2010 PUMP STATION REHABILITATION
KINGS ROW 1 PS
CIVIL SITE AND MECHANICAL PLANS

SHEET NUMBER
C2
 9 OF 48

2010 PUMP STATION REHABILITATION
QUEEN WAY PS
CIVIL SITE AND MECHANICAL PLANS

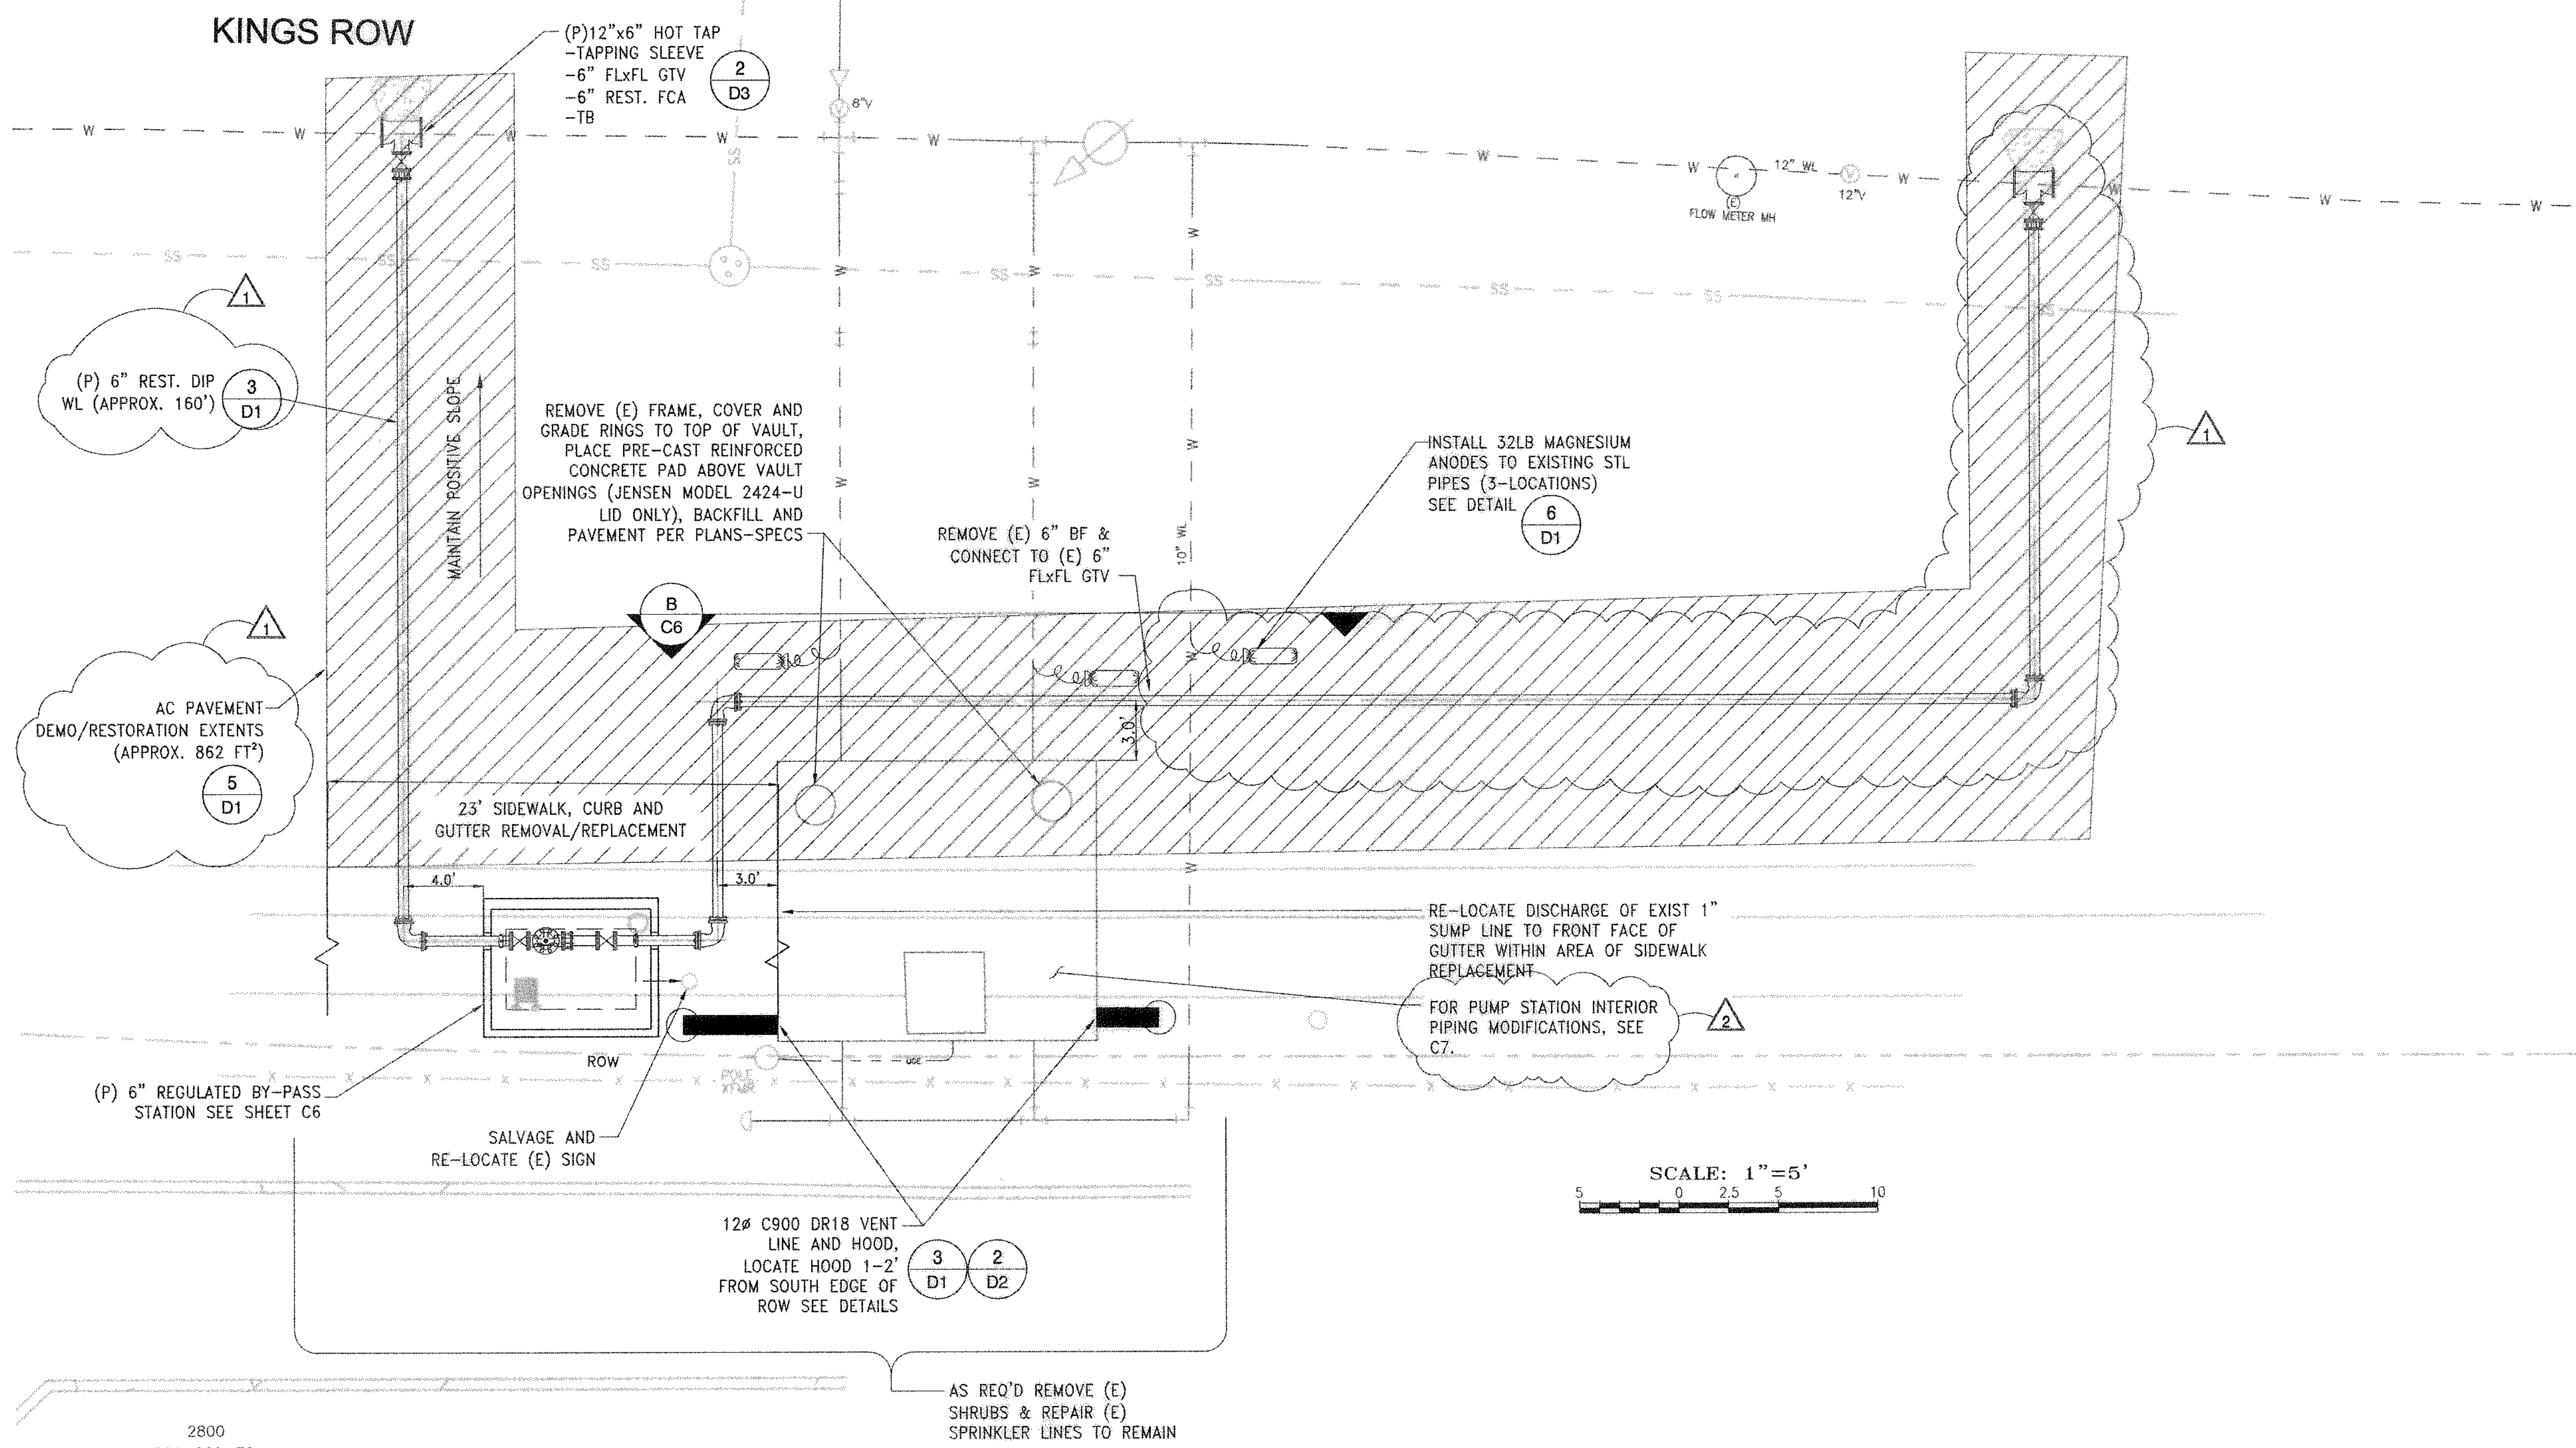
REVISION	DESCRIPTION	BY	APP	DATE
1	ADDENDUM #2 - ADDED HOT TAP AND REVISED CONN. LOCATION TO (E) 12", INCREASED AC RESTORATION AREA AND LENGTH OF DIP.			
2	ADDENDUM #2 - KINGS ROW CIVIL MECHANICAL MODIFICATIONS			
	PLANS MOVED TO SHEET C7-NEW SHEET.

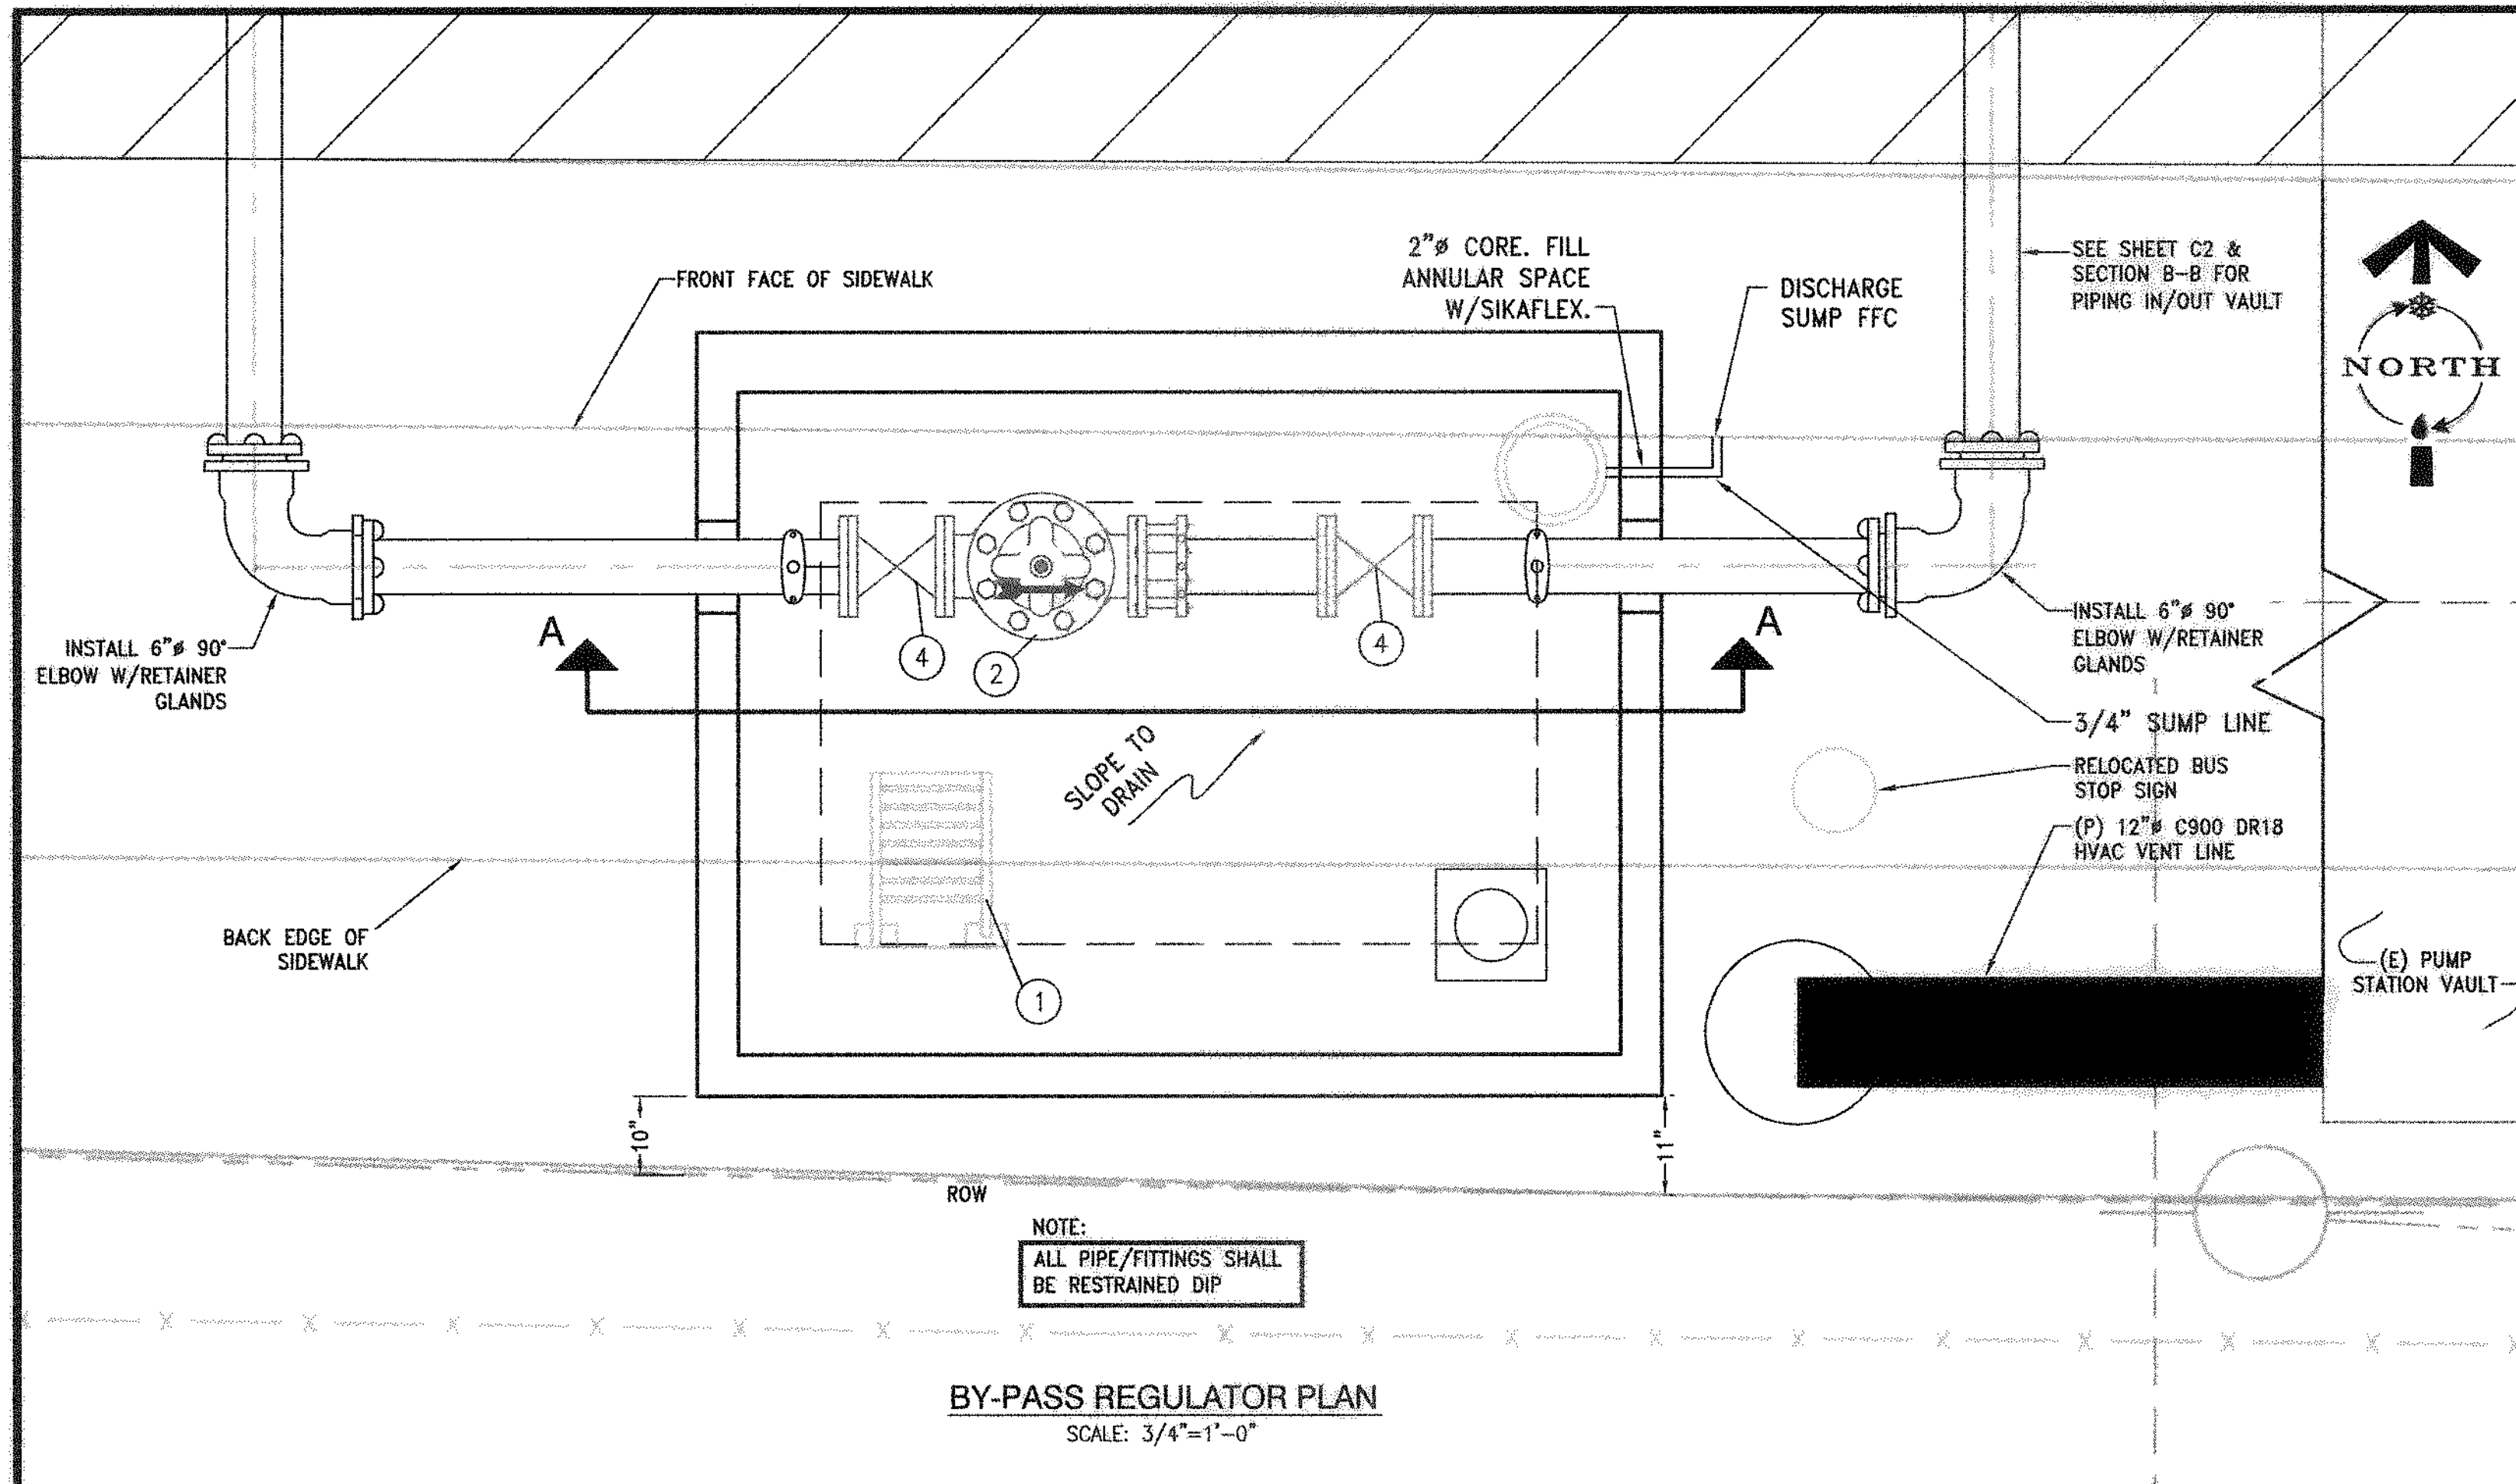
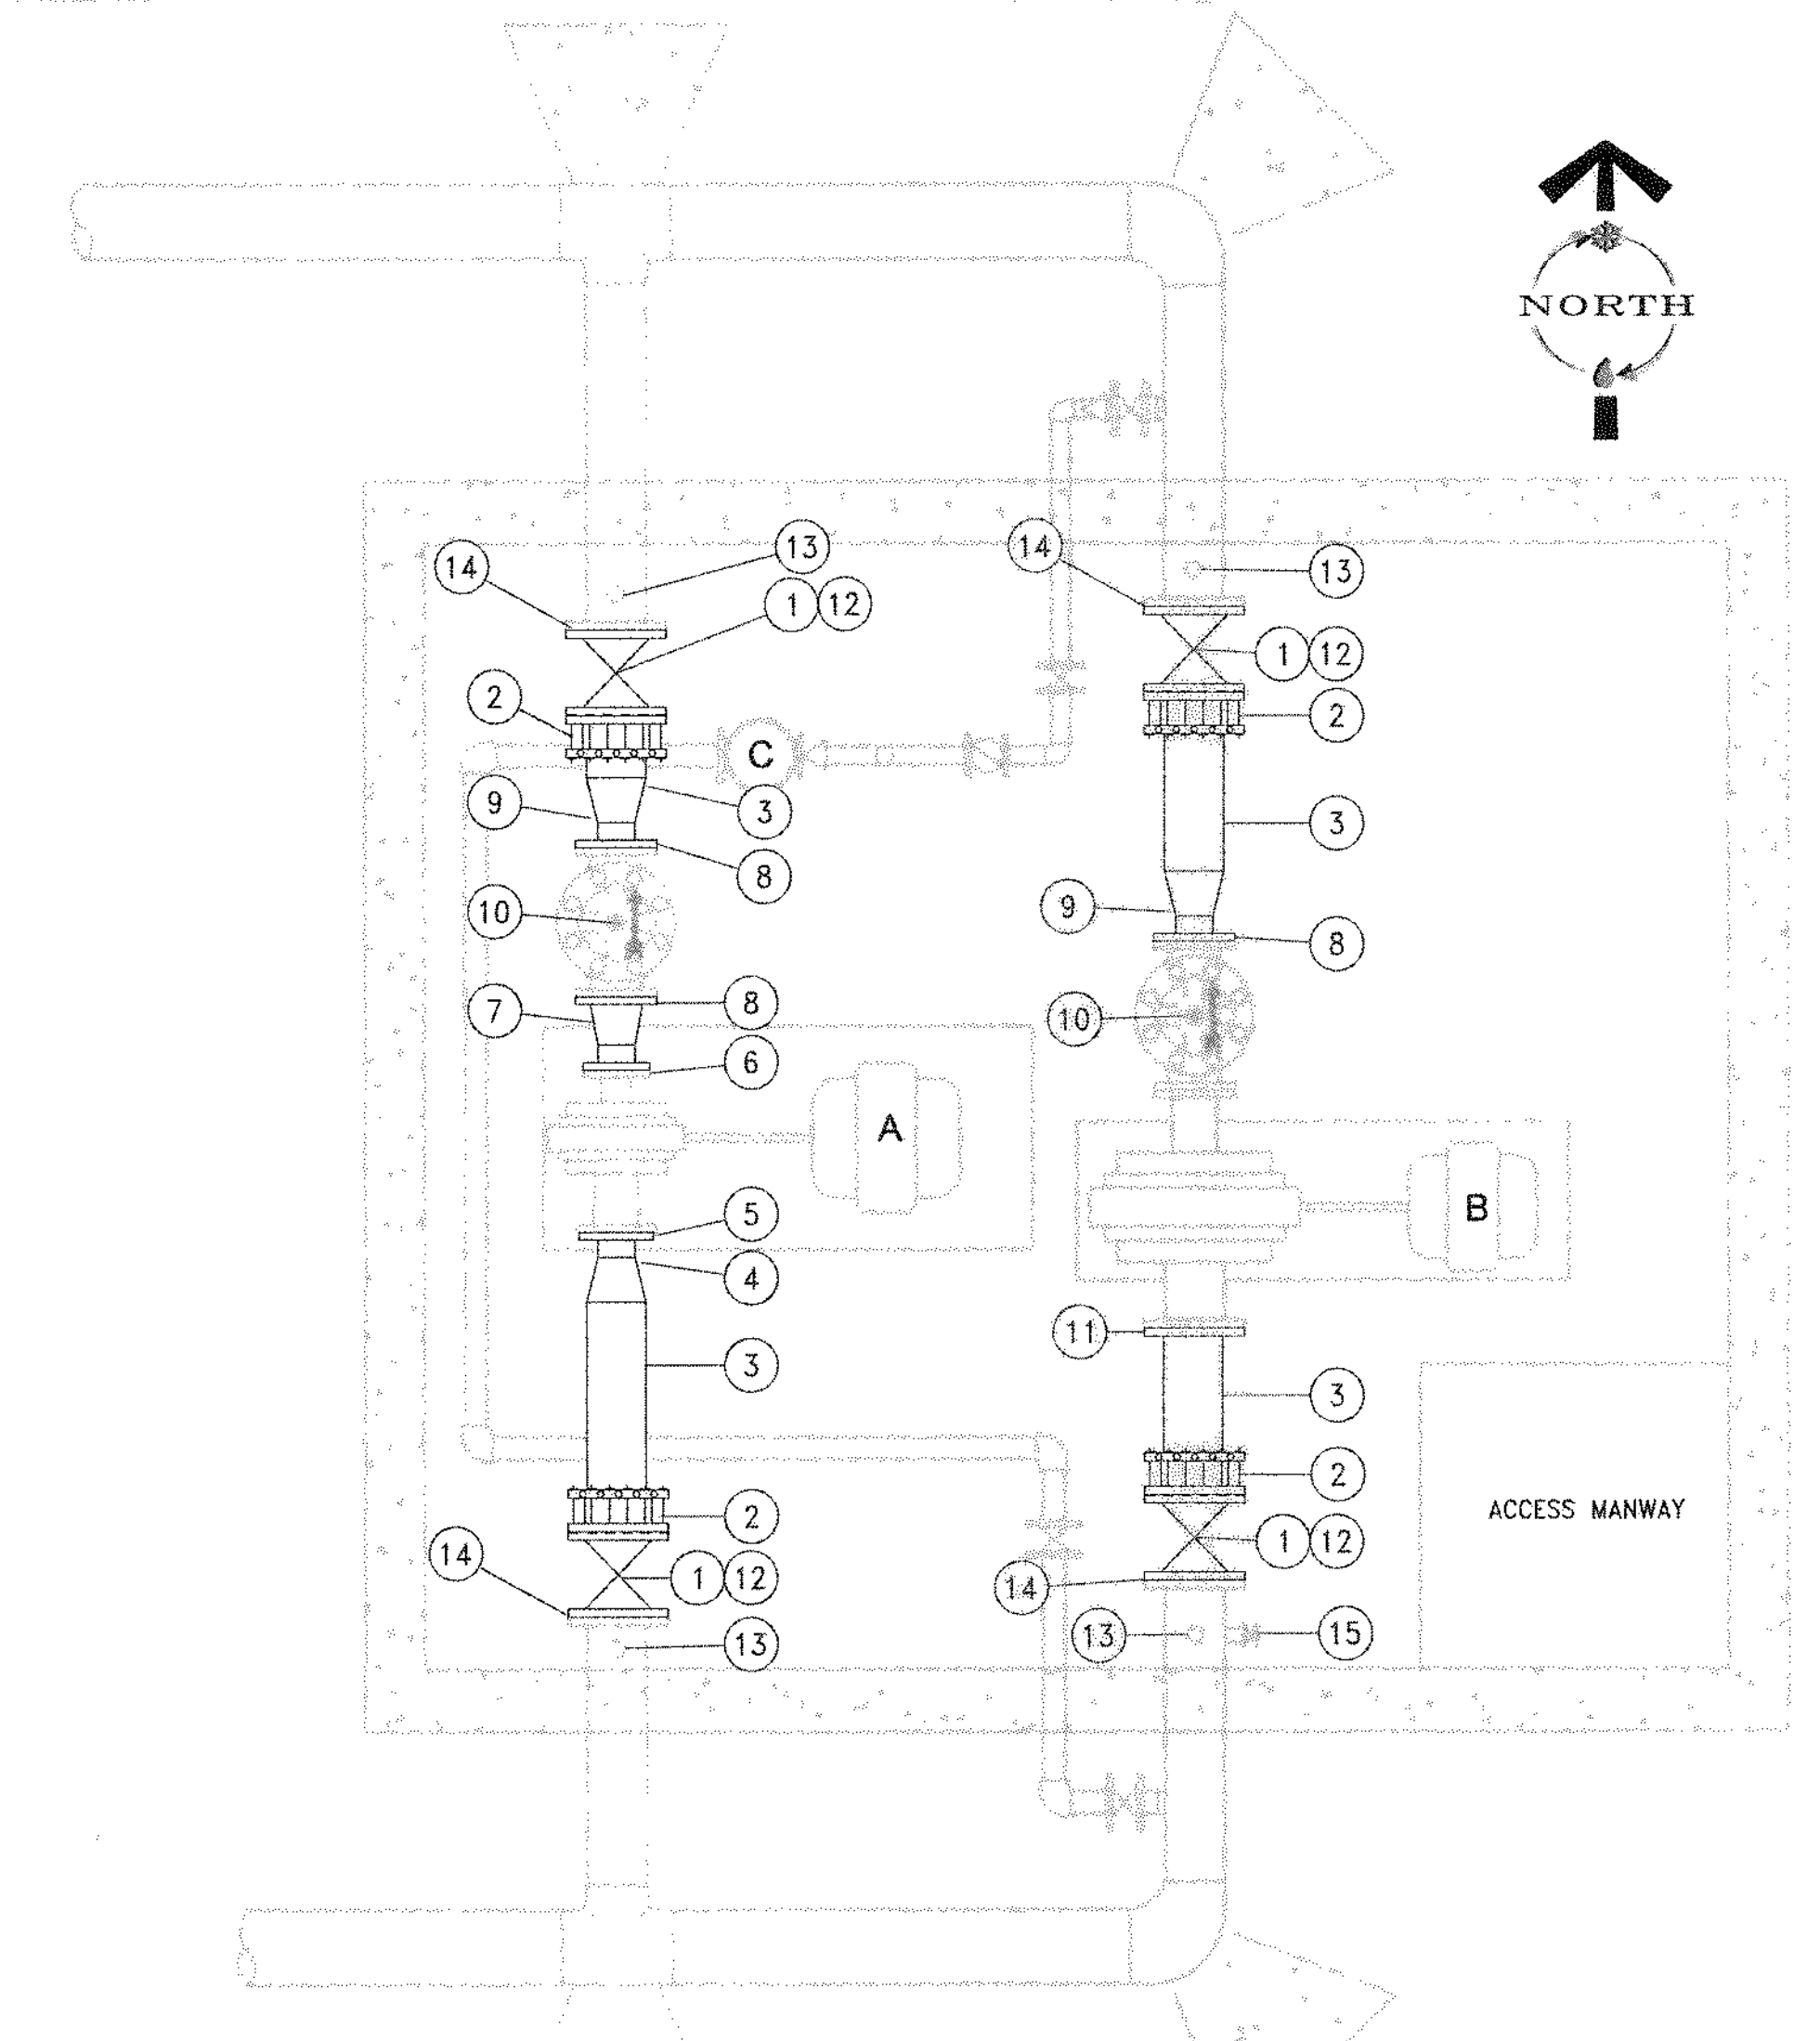
REVISION	DESCRIPTION	BY	APP	DATE
1	ADDENDUM #1	SB		1/10
2	ADDENDUM #2 - REVISED VENT INTAKE INTO VAULT LOCATION, ADDED	SB		1/10
	PIPING AND ELBOW AND INCREASED AC RESTORATION AREA
